Aqueous Solutions (owner) AQS-MFG-BMED_UPW_POLISH-NOZZLE_ORIENT
BMED_UPW_POLISH fabrication drawing NOZZLE_ORIENT (AQS-PLAN-
Type: fabrication drawing (GA / nozzle orientation / part sheet) Rev abc98b14 Issued
Created: flow graph pipeline Approved: not approved (study)
Sheet 1 of 1 AQS-DWG-001

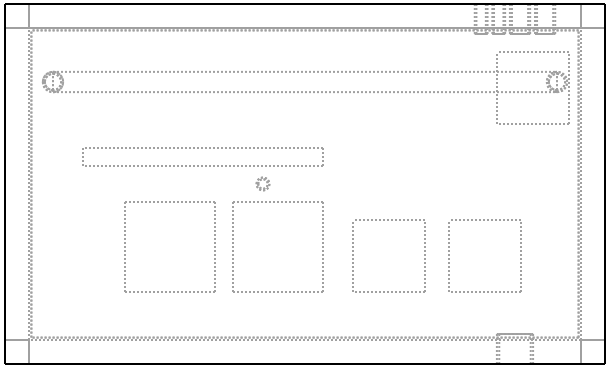
Graph revision AD - nozzle_orient: 7 schedule rows of docs-authority/nozzles/BMED_UPW_POLISH.csv at tag, face and bore
Graph revision AD - nozzle_orient: N1 DN50 VCD distillate in on -Y at z 160; outlets on +Y at z 600: N2 DN25 UPW, N3 DN25 fab UPW, N4 DN15 remineralizer,
Graph revision AD - nozzle_orient: N6 drain flush at the envelope bottom (50 datum); N7 vent flush at the envelope
Graph revision AD - nozzle_orient: Atmospheric open-bore tube stubs per duty section 4 (atmospheric joints are ho
